REQUEST FOR BIDDING INTERPRETATION (RFBI)

Project No.: 000000000009324
Project Name: OES Security Upgrades
Location: Mather, Sacramento County, CA

Drawing Reference: C501 Project Manual Reference: _____

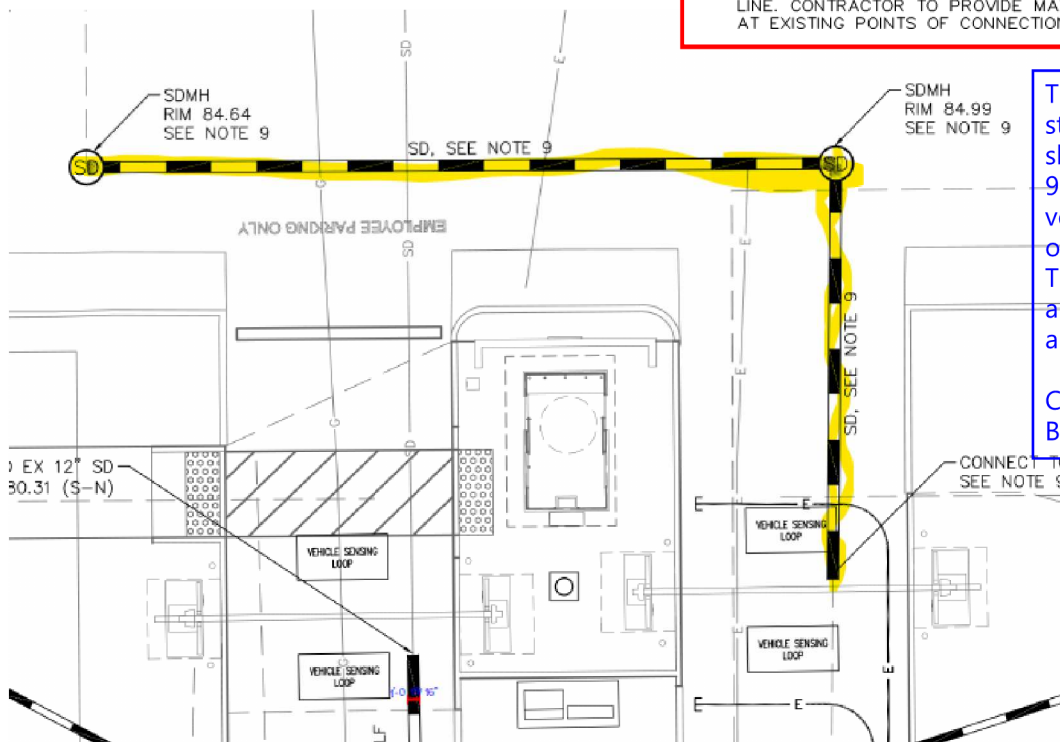
On sheet C501, a new storm drain run does not have a line size or depth identified. For bidding purposes, please provide a line size and invert depth.

9. CONTRACTOR TO FIELD VERIFY SIZE AND LOCATION OF EXISTING STORM DRAIN LINE. CONTRACTOR TO PROVIDE MAXIMUM SLOPE POSSIBLE TO CONNECT INVERTS AT EXISTING POINTS OF CONNECTION.

The location of the existing storm drain line has been shown from asbuilts. Per note 9 on sheet C501, contractor to verify size, depth and location of the existing storm drain. The size of line is approximately 4" diameter and 4' depth.
